V2500-A1/A5/D5 PROPULSION SYSTEM SERVICE BULLETIN

This document transmits the Revision 7 of Service Bulletin V2500-ENG-75-0084.

ENGINE – AIR ACTIVE CLEARANCE CONTROL (ACC) – REPLACEMENT OF TITANIUM TUBES MADE FROM
X10 MATERIAL FOR REWORK/REPAIR BY TUBE REPLACEMENT

Rework of active clearance control (ACC) made from titanium
 Fig.1 (Sheet 1 of 5)

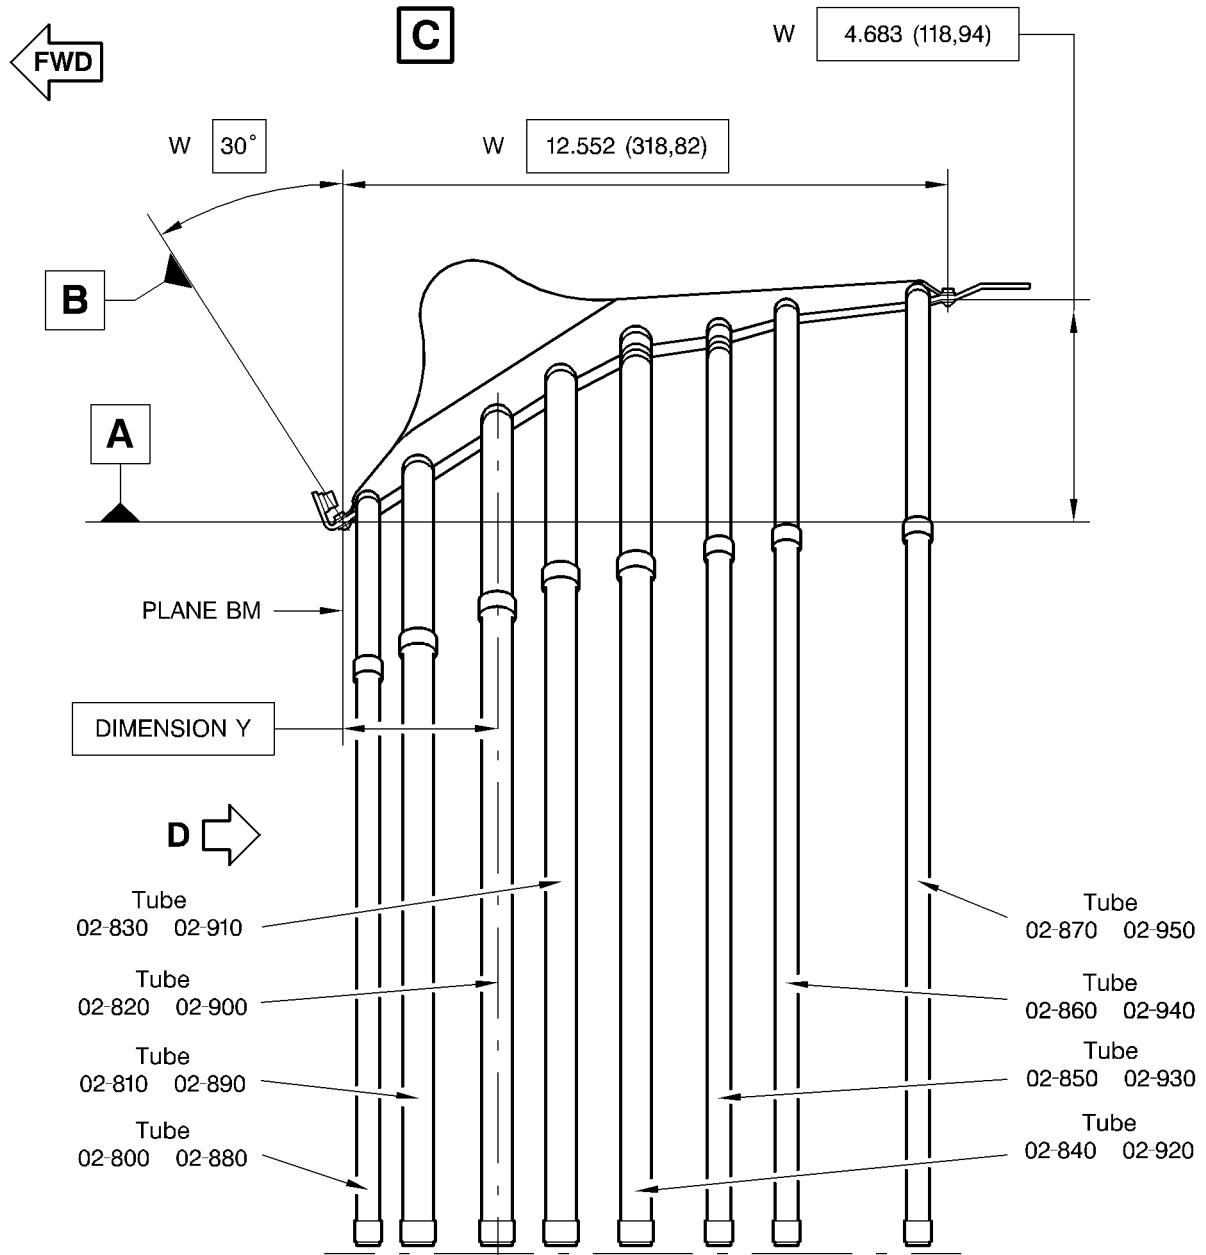
(5) For replacement tubes refer to 2.
(1) Material Information and Fig.1
(Sheet 1 and Sheet 2) and Fig.2
(Sheet 1 and Sheet 2)

Rework of active clearance control (ACC) made from titanium
 Fig.1 (Sheet 2 of 5)

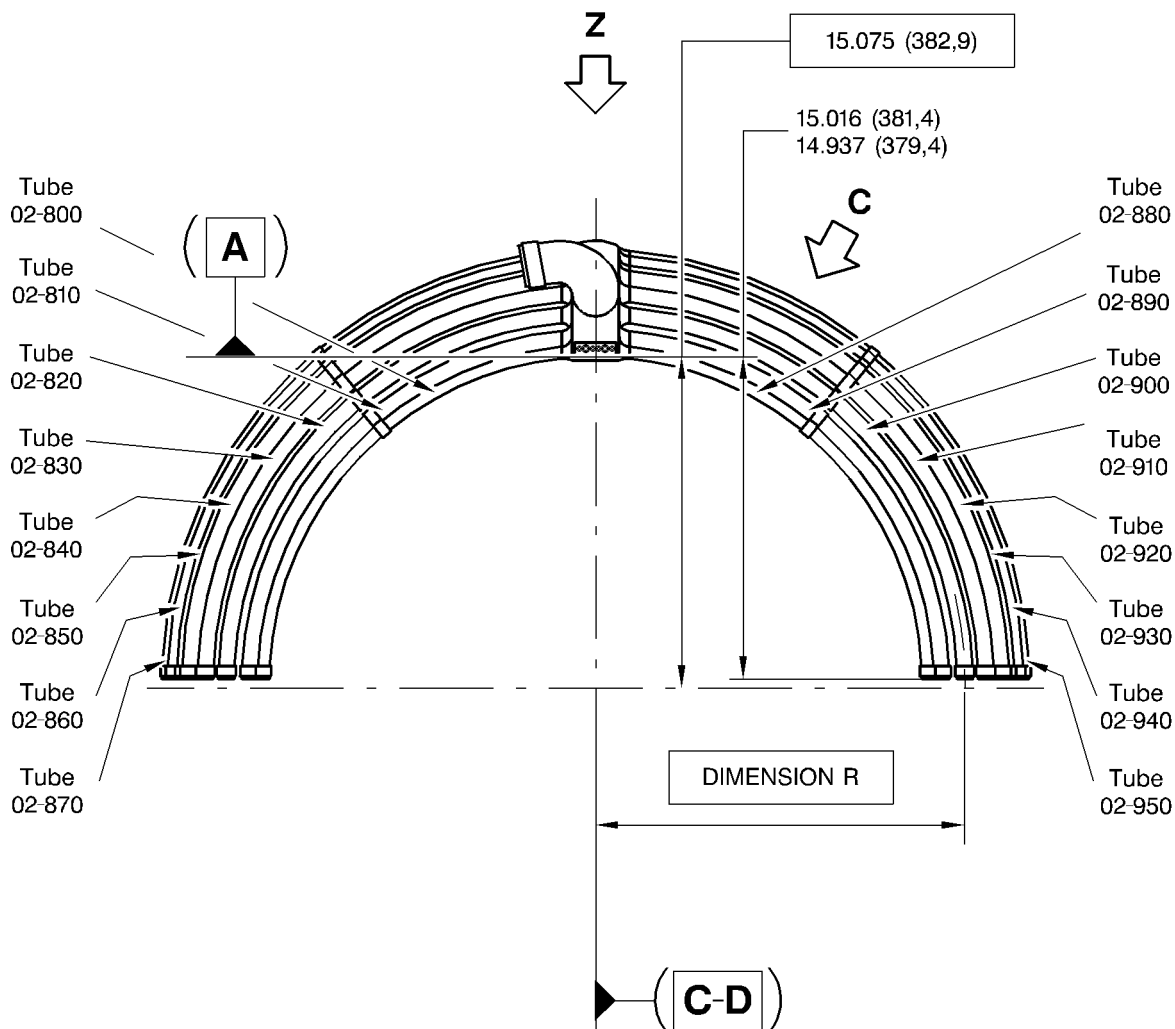
Use CoMat 03-246 welding material.
For purity of welds refer to TASK
70-31-13-310-501. Use applicable
fixture to get correct weld repair.
Refer to Fig.1 (Sheet 2) and Fig.2
(Sheet 2).

Rework of active clearance control (ACC) made from titanium
Fig.1 (Sheet 3 of 5)

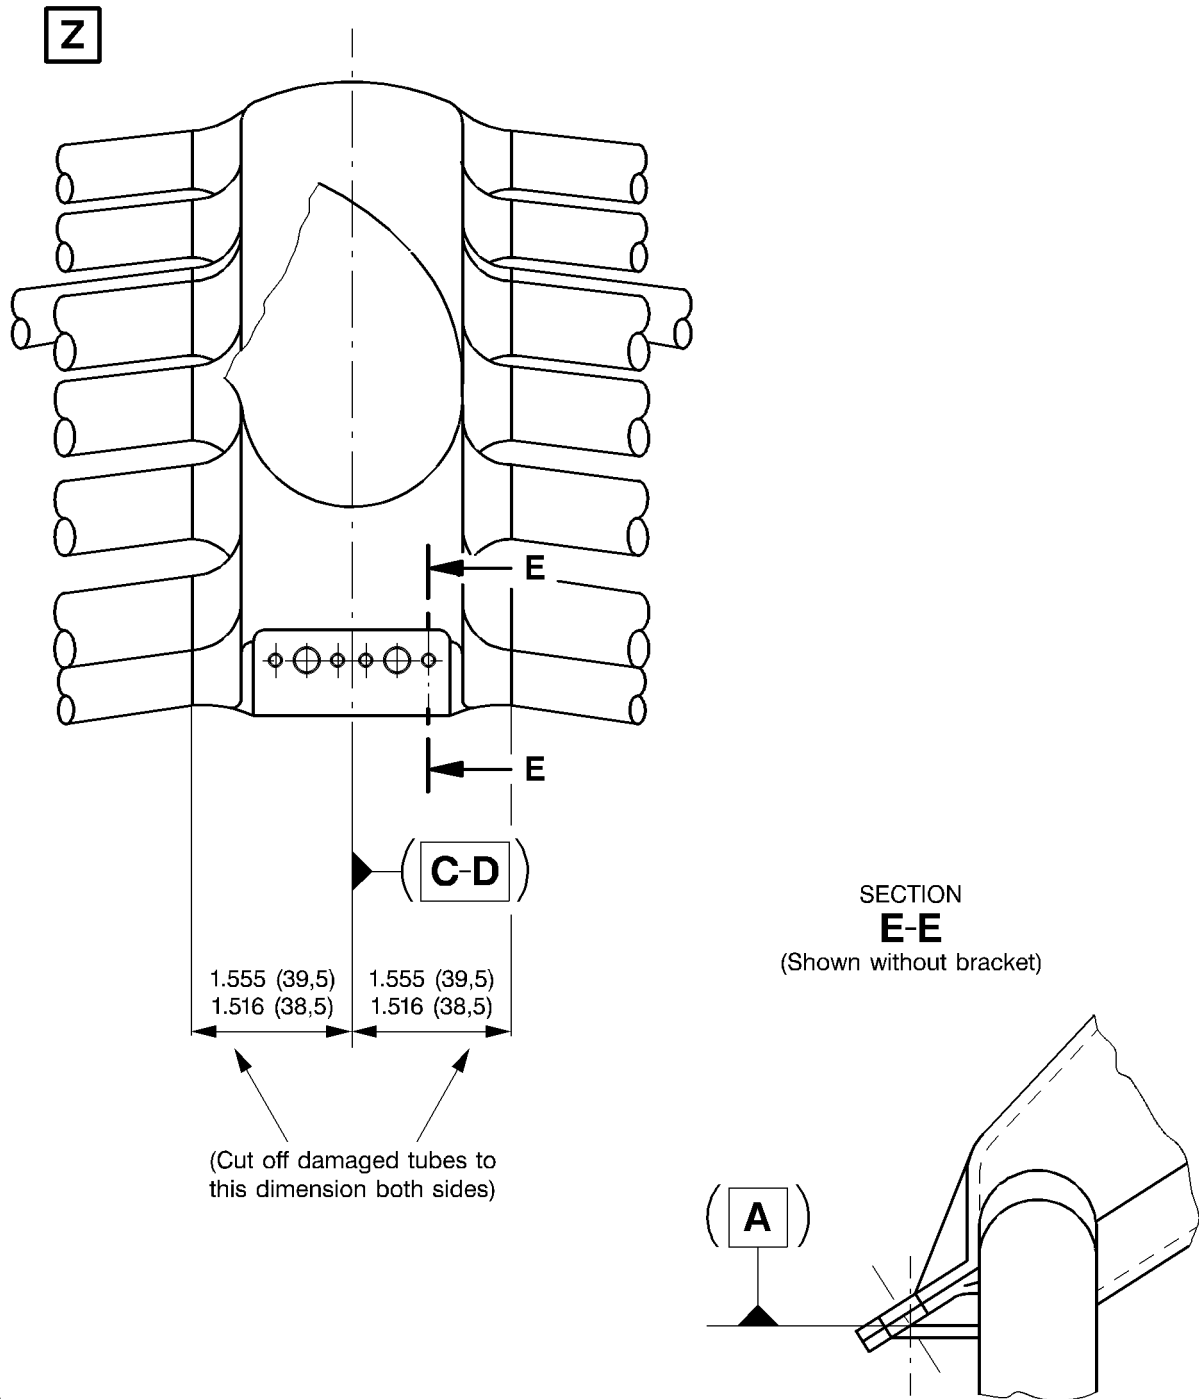
(4) Cut off damaged tubes

Refer to Fig.1 (Sheet 3) and Fig.2
(Sheet 3) for dimensions.

Rework of active clearance control (ACC) made from titanium
 Fig.1 (Sheet 4 of 5)

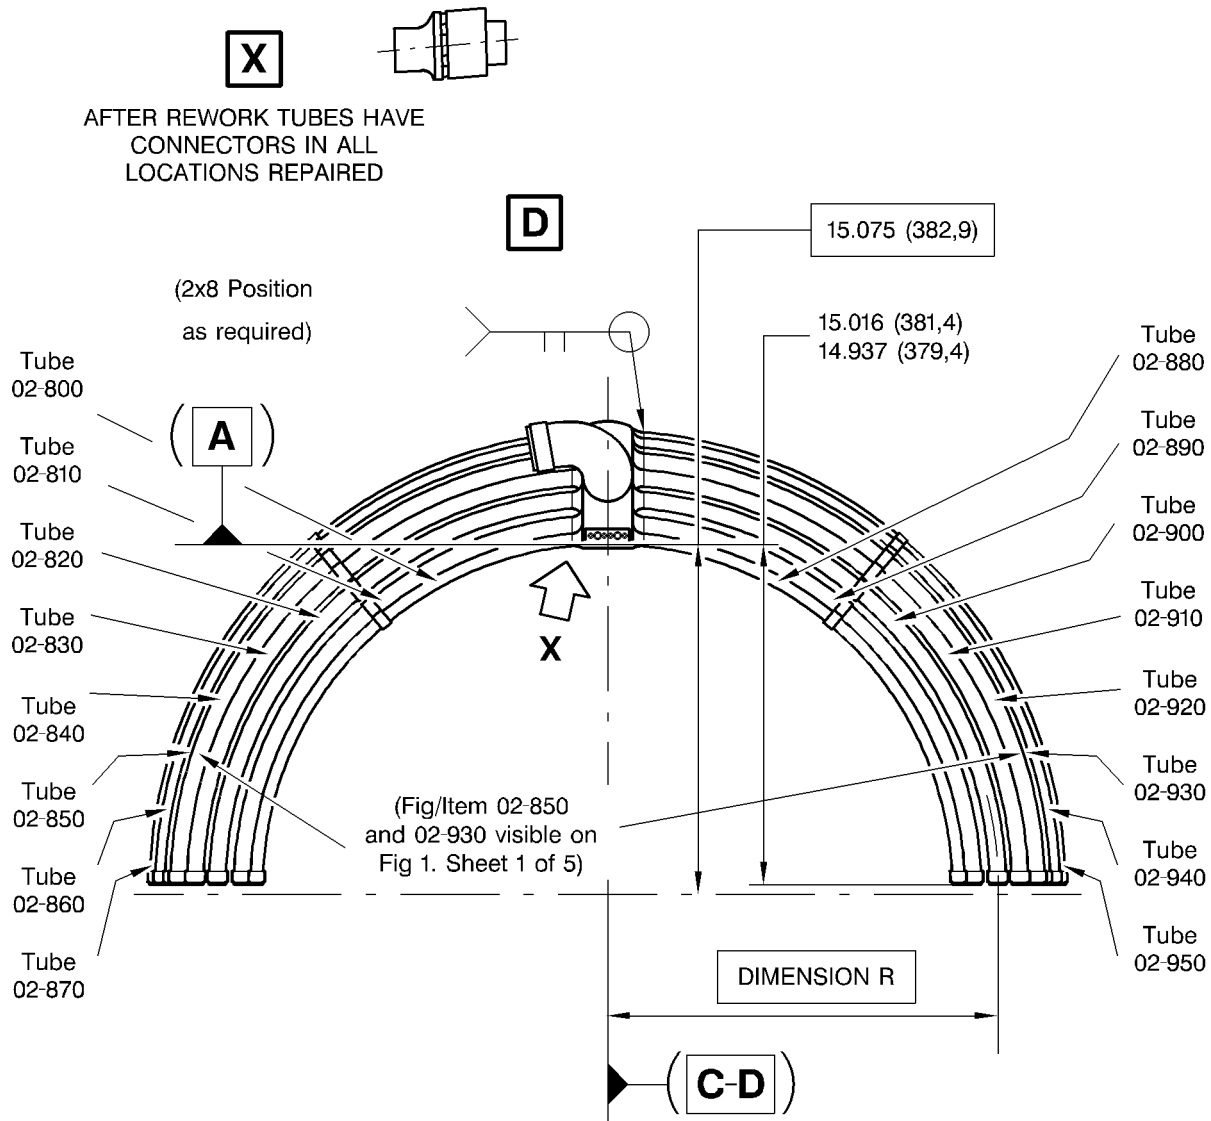
(6) Machine tube end to attach
replacement tube in position.
Machine the tube end on the duct as
required to get the tube in correct
position

Refer to Fig.1 (Sheet 4) and Fig.2
(Sheet 4).

| (12) Examine the areas dimensionally | Refer to Fig.1 (Sheet 4) and Fig.2 (Sheet 4). |

Rework of active clearance control (ACC) made from steel with titanium tubes
Fig.3 (Sheet 1 of 5)

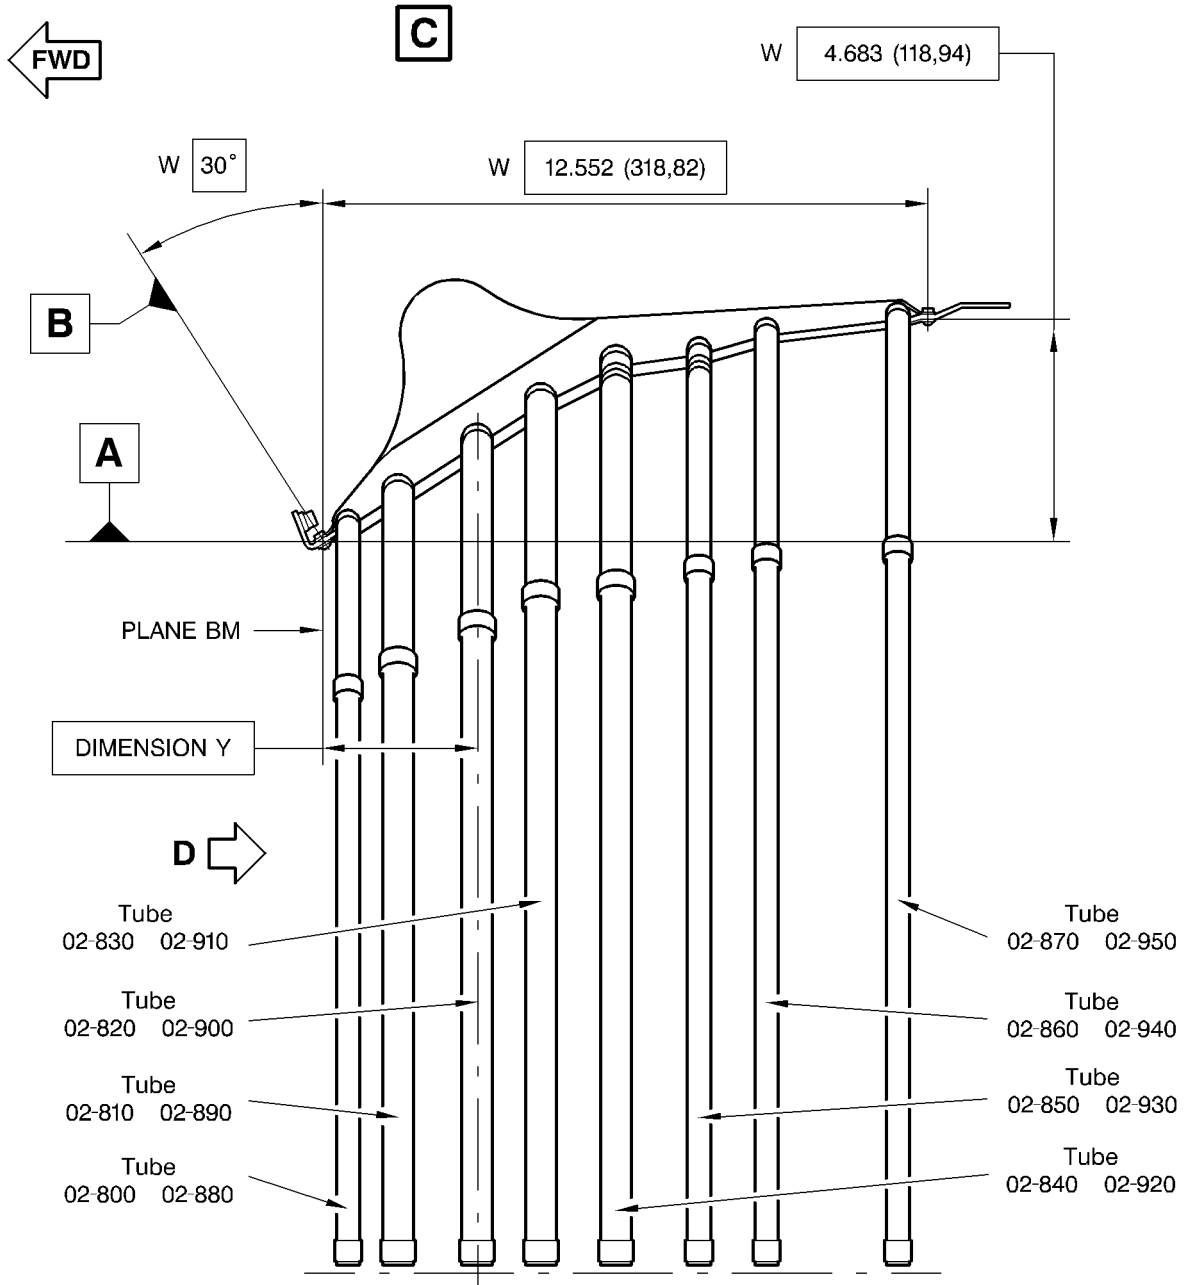
(4) For replacement tubes refer to 2. (3) and 2. (4) Material Information and
Fig.3 (Sheet 1 and 2) and Fig.4 (Sheet 1 and 2).

| (4) Cut off damaged tubes | Refer to Fig.3 (Sheet 1) and Fig.4 (Sheet 3) for dimensions. |

Rework of active clearance control (ACC) made from steel with titanium tubes
 Fig.3 (Sheet 2 of 5)

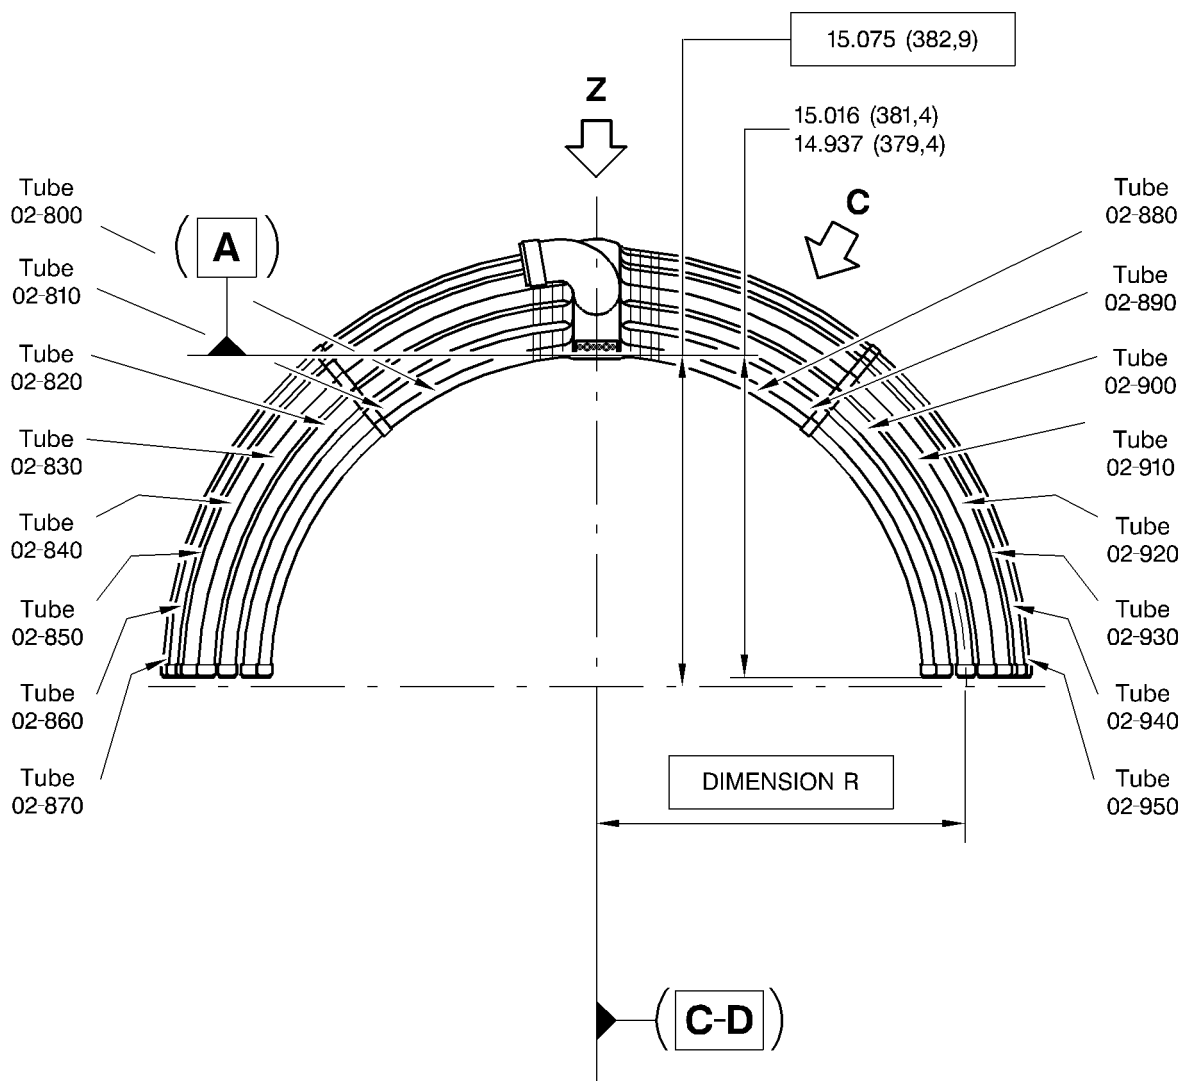
| (8) Weld replacement tube into position. Refer to TASK 70-31-13-310-501. Protective atmosphere is required | Use CoMat 03-204 welding filler wire. For purity of welds refer to TASK 70-31-13-310-501. Use applicable fixture to get correct weld repair. Refer to Fig.3 (Sheet 2) and Fig.4 (Sheet 2). |

Rework of active clearance control (ACC) made from steel with titanium tubes
Fig.3 (Sheet 4 of 5)

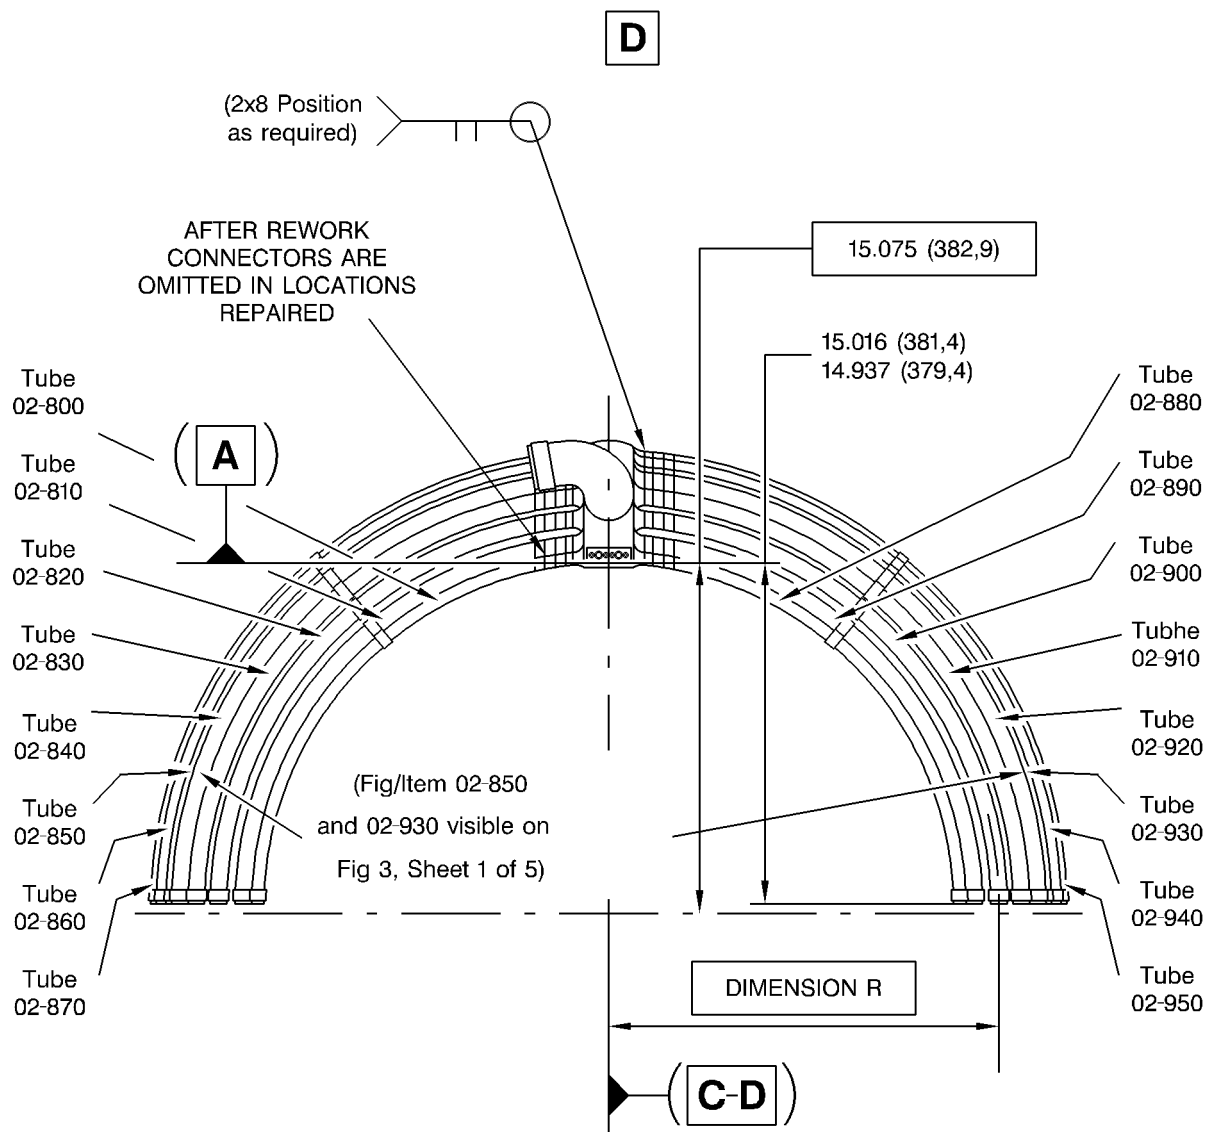
| (5) Machine tube end to attach replacement tube in position. Machine the tube end on the duct as required to get the tube in correct position | Refer to Fig.3 (Sheet 4) and Fig.4 (Sheet 4). |
| (11) Examine the areas dimensionally | Refer to Fig.3 (Sheet 4) and Fig.4 (Sheet 4). |
